Change Notice Information Announcement

GREEN Flag Notice

Product Name(s): GV7AC08

Product Line Description: GV7 Motor Breakers

Product Photos

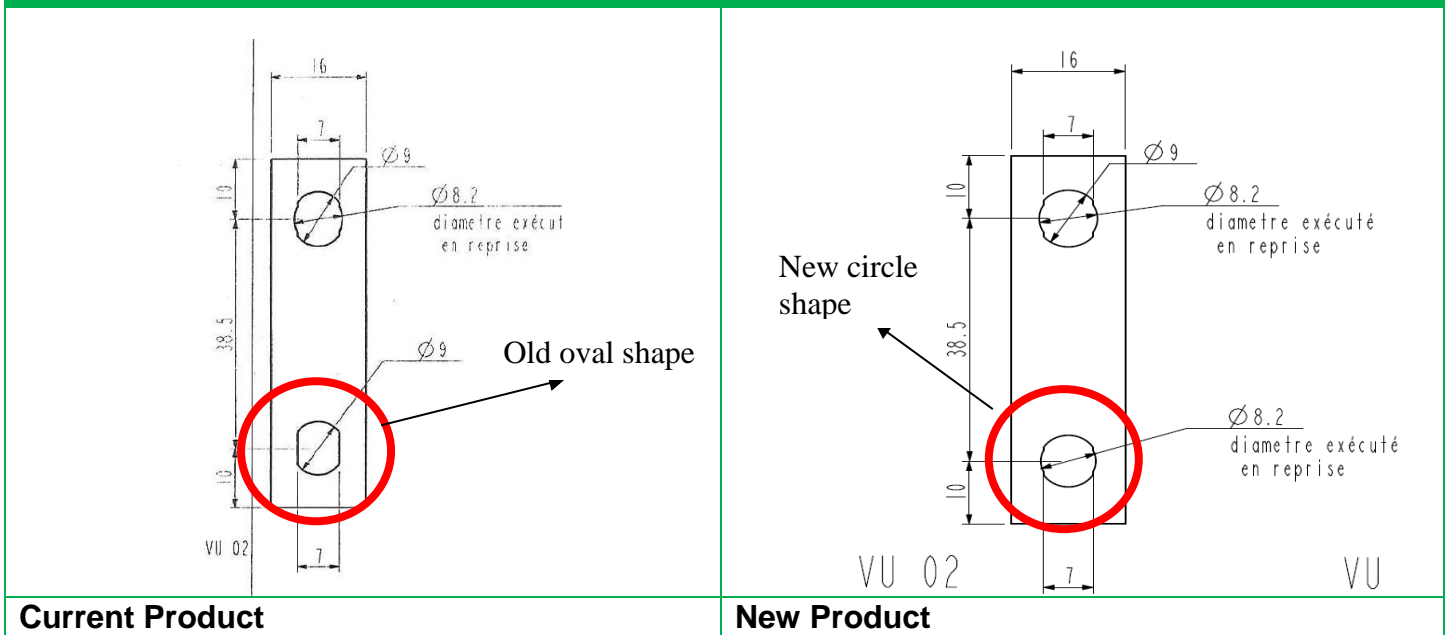
The hole shape and diameter in GV7AC08, which is the connecting link between GV7 breaker and LC1D115/150 contactor, has changed shape. Previously, the top hole in the GV7AC08 connecting link was circular and the bottom hole was oval shape, making it difficult for the customer to fit a $\phi 8$ mm fixing bolt in the oval hole. Now, the bottom hole is in a circular shape so both holes shall be circular with $\phi 8.2$ mm diameter.
